Well Name: WF FEDERAL 1	Well Location: T30N / R14W / SEC 1 / NENW / 36.846924 / -108.263094	County or Parish/State: SAN JUAN / NM
Well Number: 2	Type of Well: OTHER	Allottee or Tribe Name:
Lease Number: NMNM101552	Unit or CA Name:	Unit or CA Number:
US Well Number: 3004532269	Well Status: Inactive	Operator: HILCORP ENERGY COMPANY

Notice of Intent

Type of Submission: Notice of Intent	Type of Action: Plug and Abandonment
Date Sundry Submitted: 01/21/2022	Time Sundry Submitted: 09:18
Date proposed operation will begin: 02/01/2022

CONDITIONS OF APPROVAL

PROPOSED P&A WELLBORE SCHEMATIC

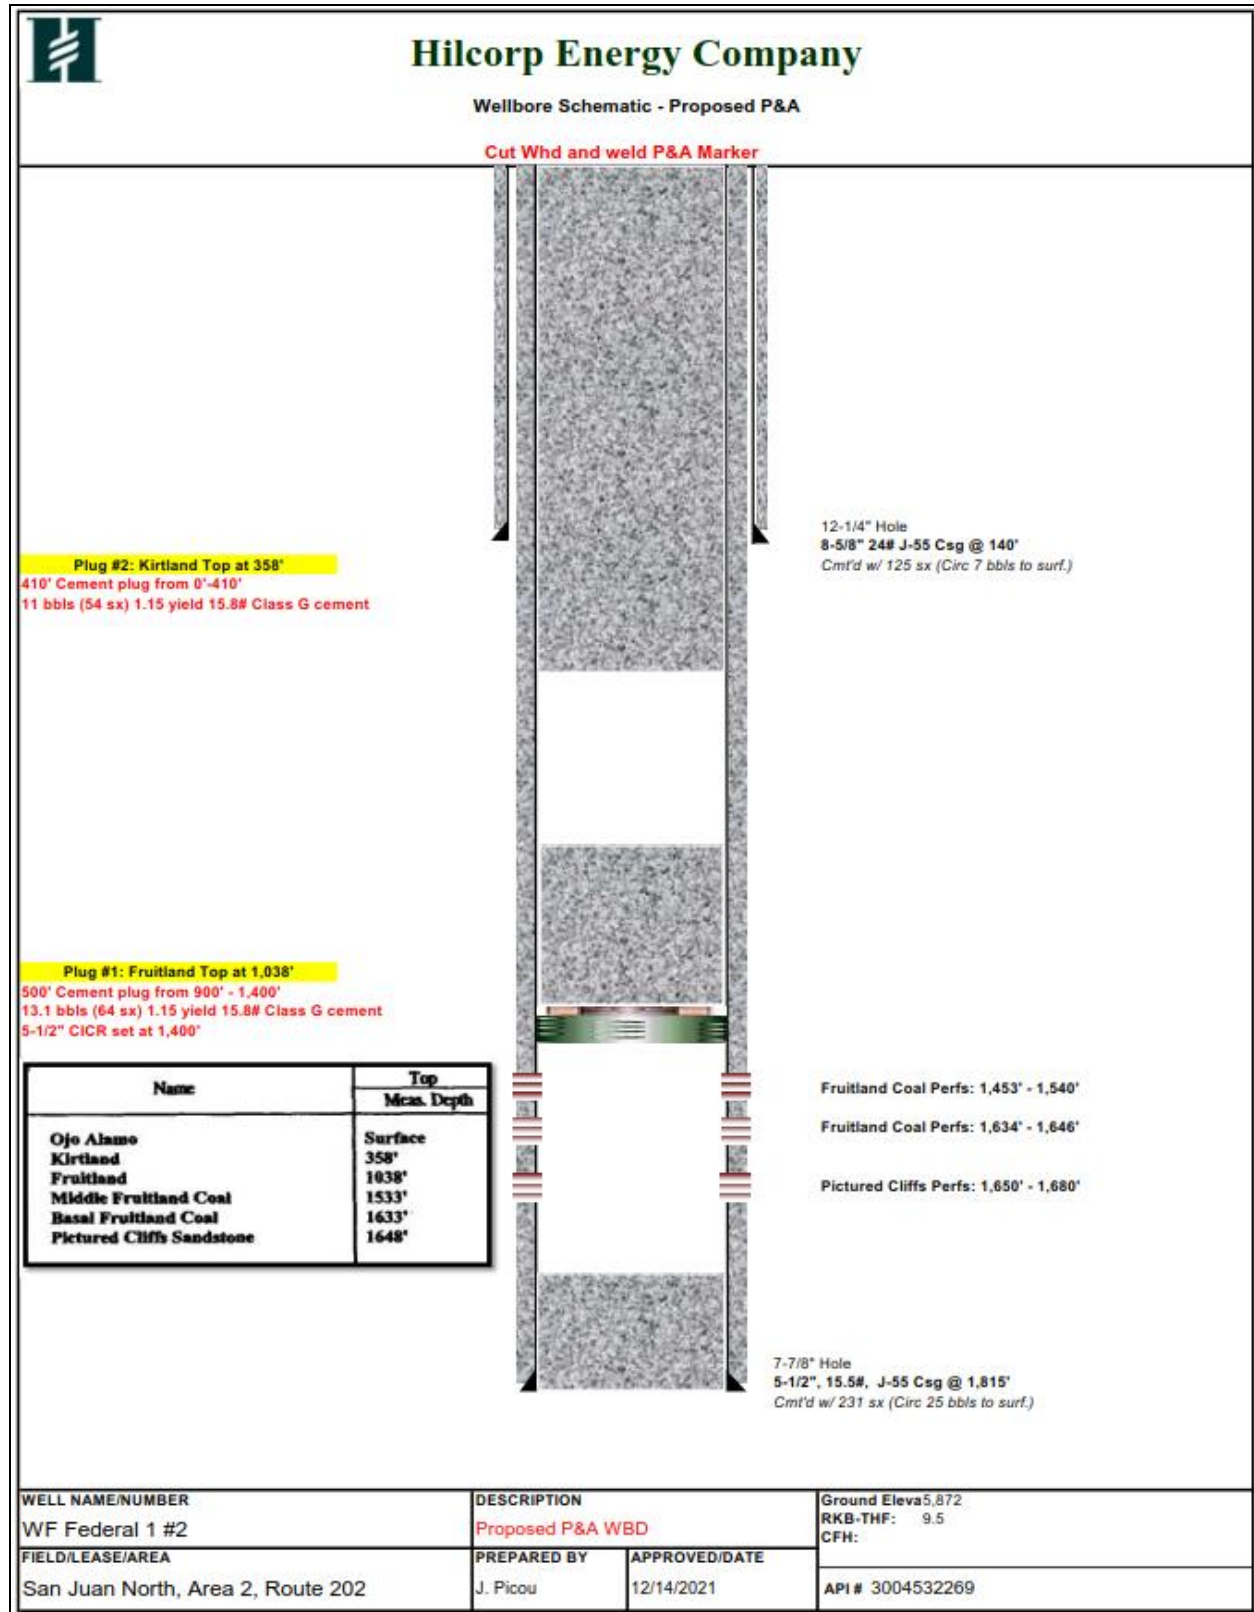
1. Plugging operations authorized are subject to the attached "General Requirements for Permanent Abandonment of Wells on Federal and Indian Lease."
2. The following modifications to your plugging program are to be made:
 - a) Add a plug to cover the Pictured Cliffs formation top at 1648 feet.
3. Farmington Office is to be notified at least 24 hours before the plugging operations commence at (505) 564-7750.

- BLM pick for the Kirtland formation top varies from Operator pick.
- Add a plug to cover the Pictured Cliffs formation top at 1648'.
- The plugs proposed in the P&A procedure, with recommended changes, will adequately protect any freshwater sands in this well bore.
- Fruitland coal perms 1453' – 1540' and 1634' – 1646'. Squeeze perms in Pictured Cliffs 1650' – 1680'.
- H₂S has been reported in this well at 15 ppm. Ensure H₂S precautions are in place.
